Docket No.: STN 50-470F

May 10, 1983
LD-83-045

Subject: Open Items 1 and 4, Revised Section 3.11 of CESSAR-F

Reference: Letter LD-82-063, A. E. Scherer to D. G. Eisenhut, dated July 1, 1982

Figure
3.11A-4A

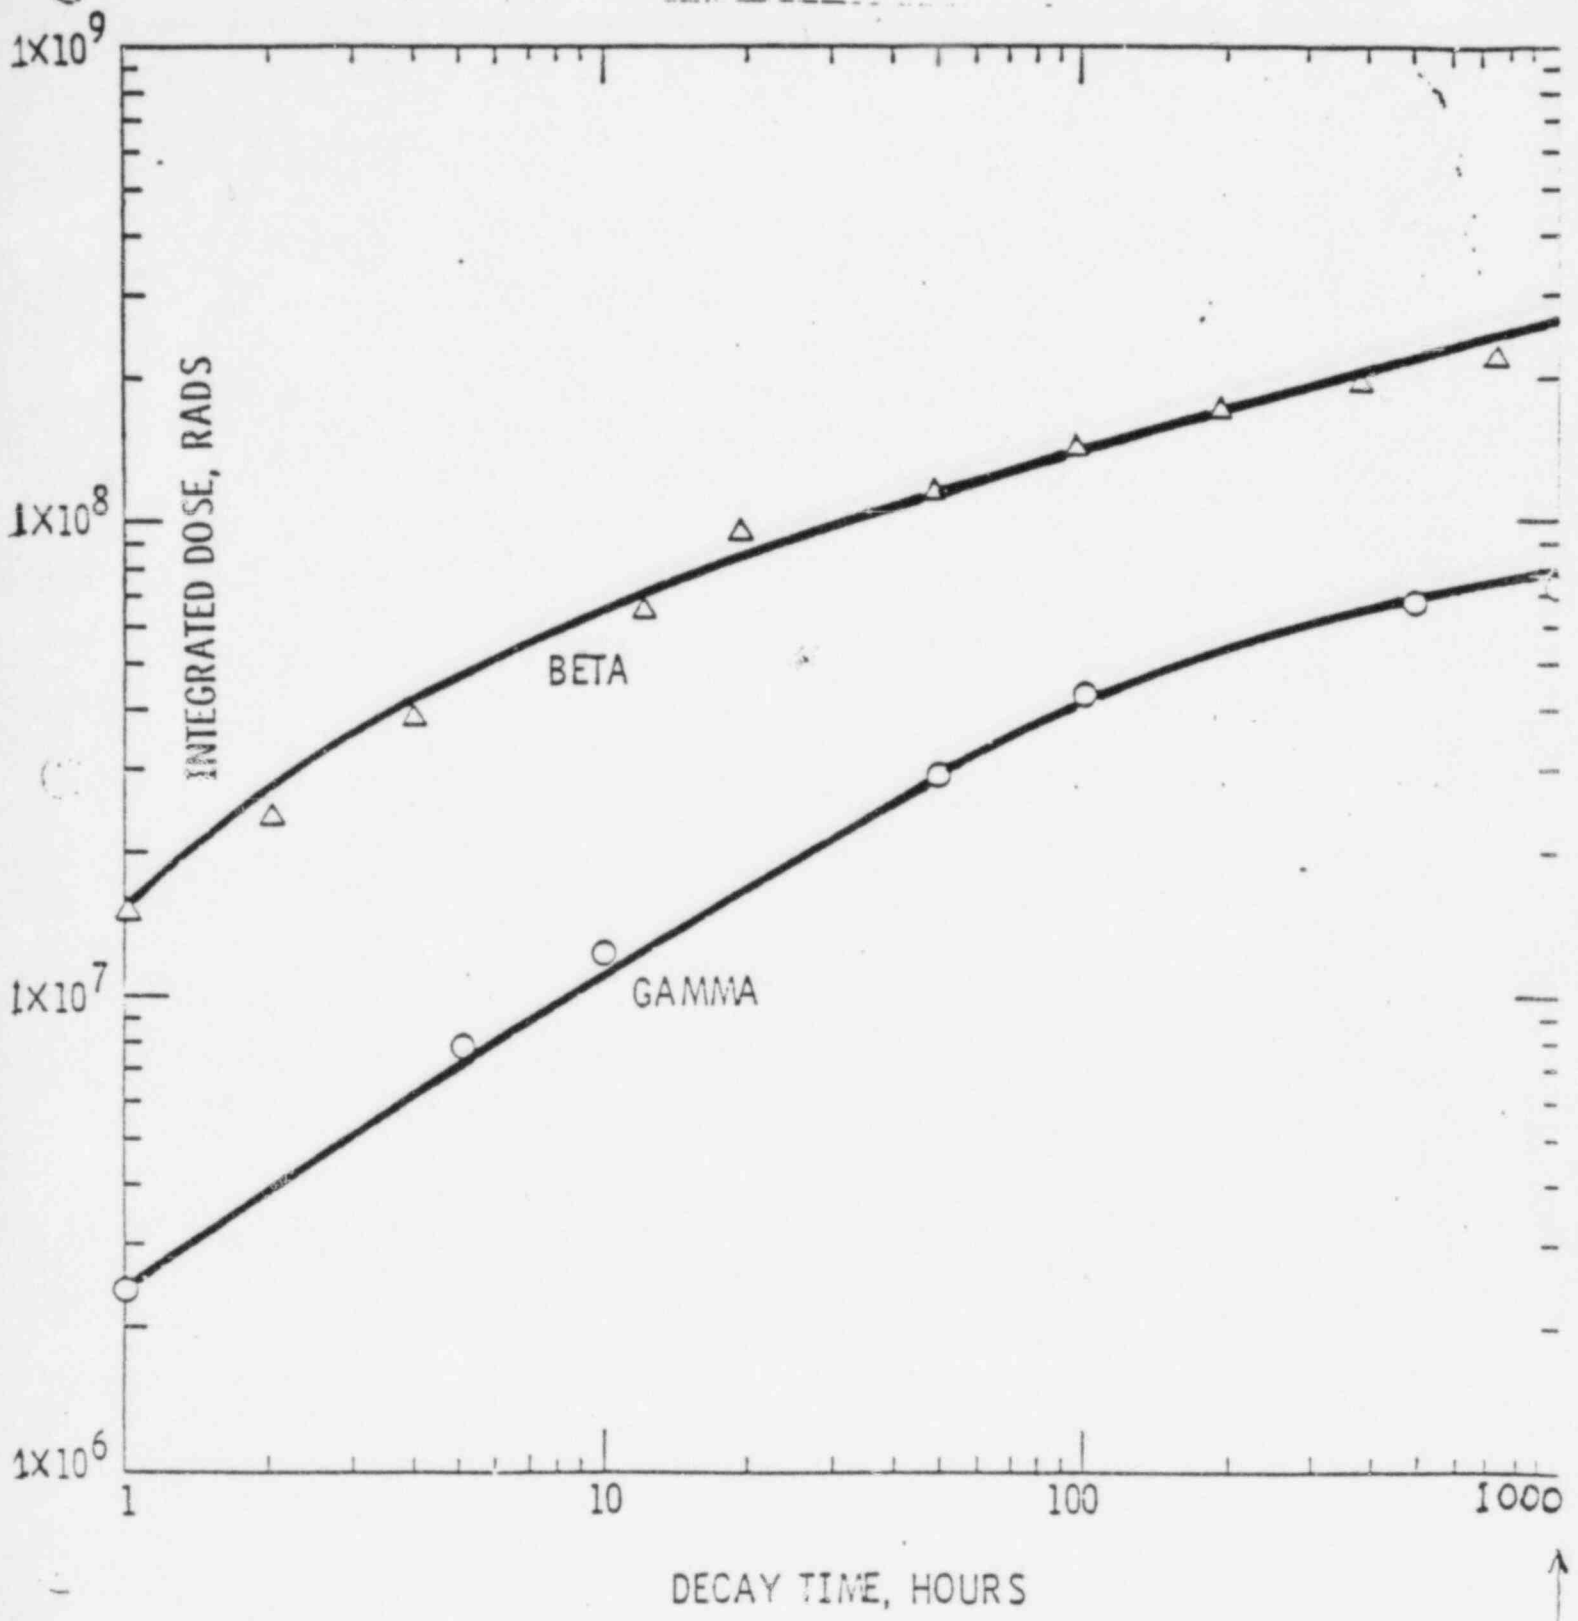
NEW FIG.

<p>TYPICAL INTEGRATED DOSE IN CYLINDRICAL CONTAINMENT FOLLOWING LOCA</p>	<p>Figure 3.11A-4B</p>
--	--	----------------------------

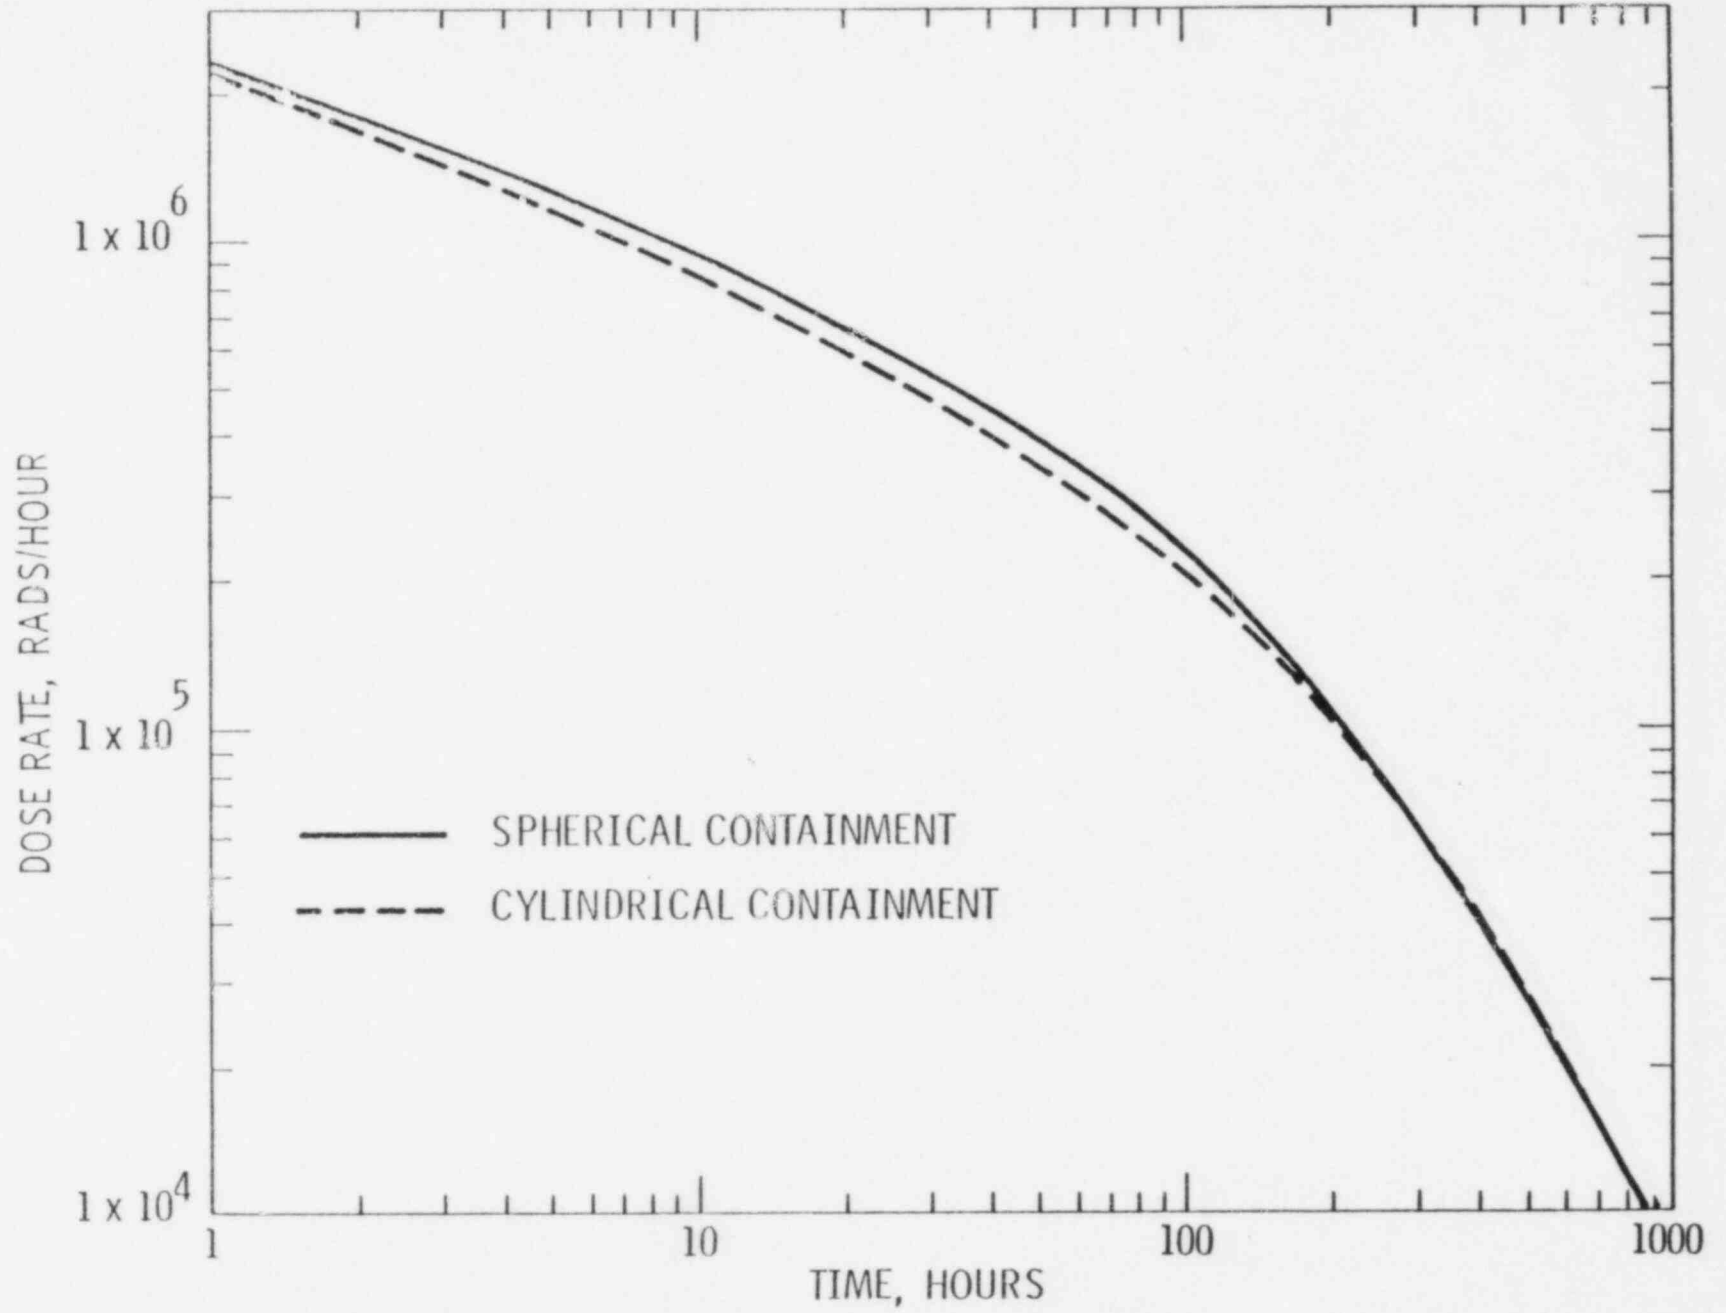
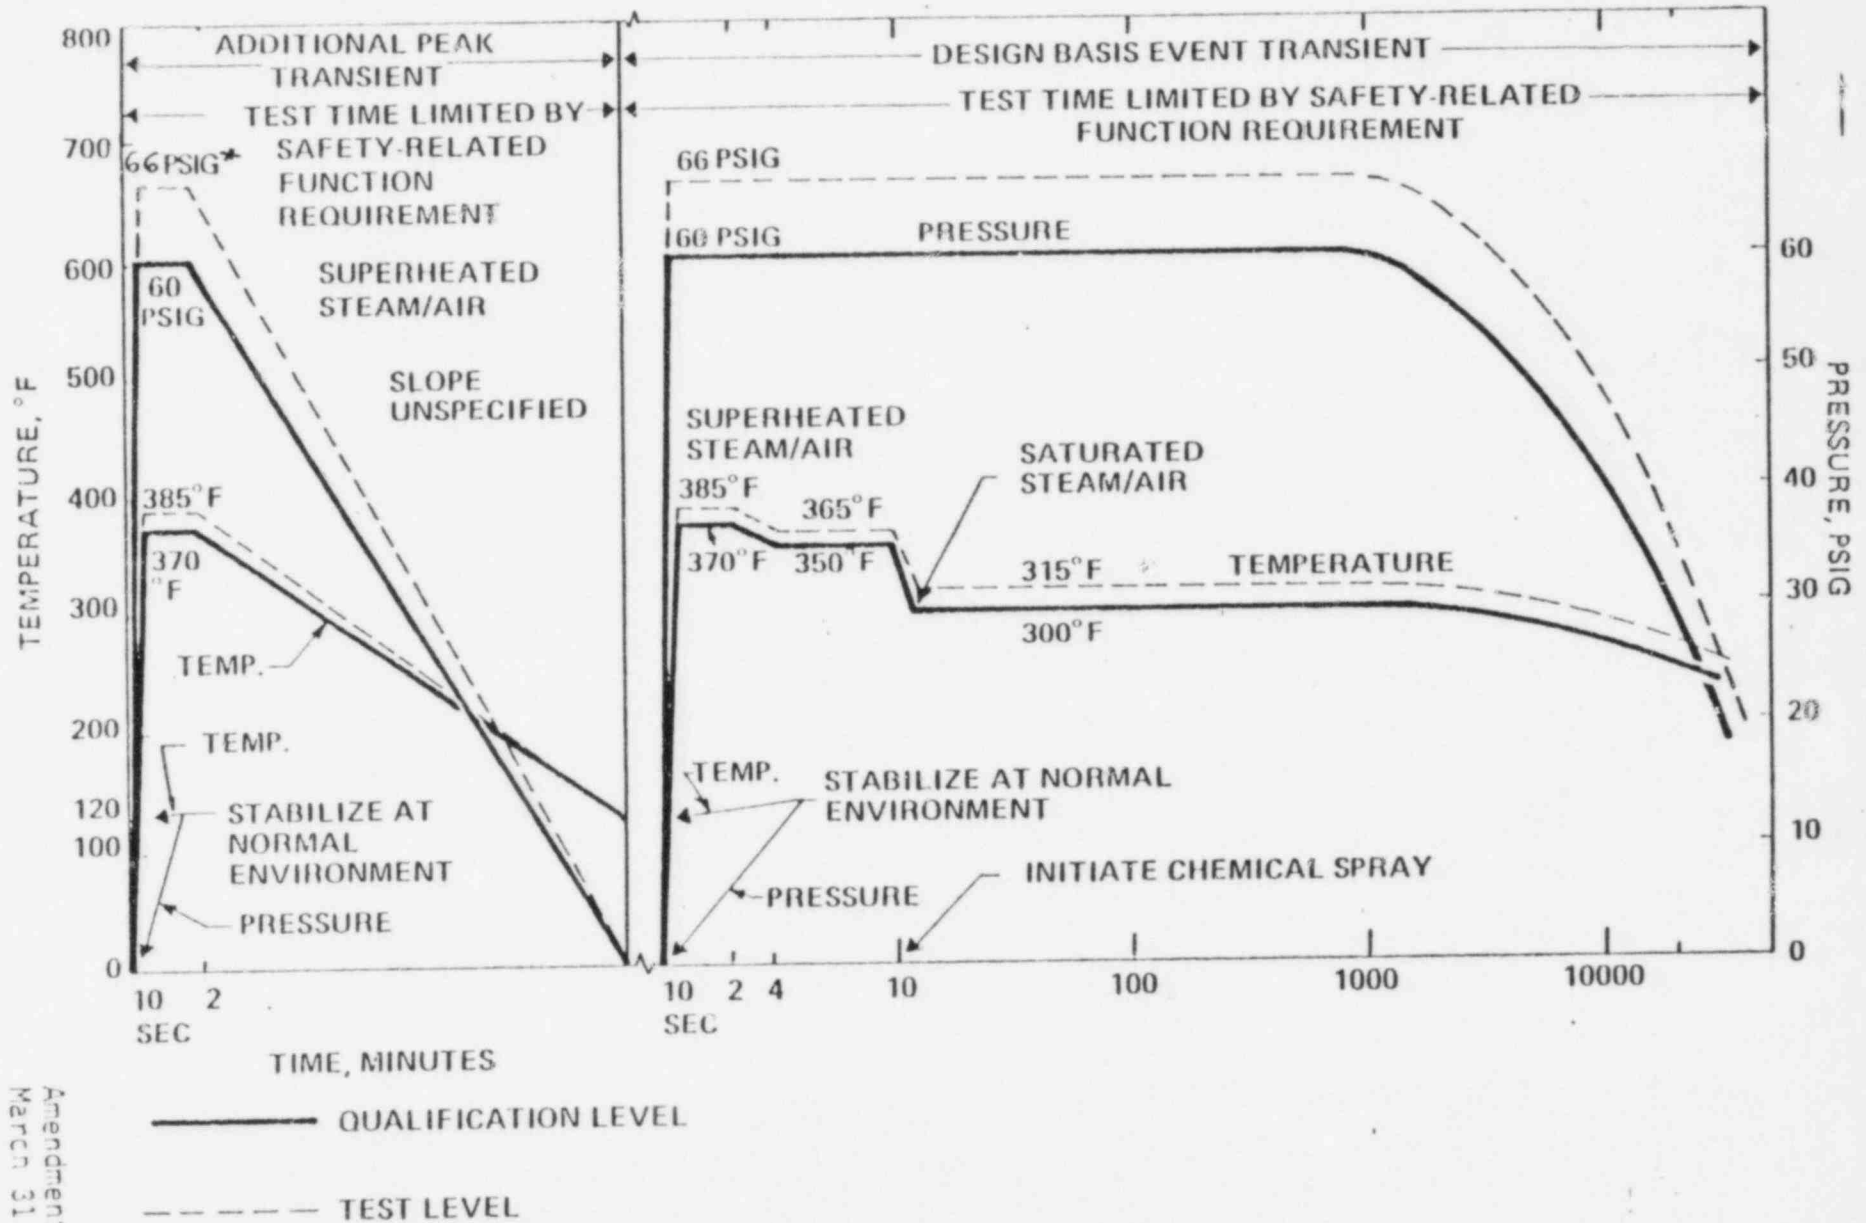
NEW
FIG.
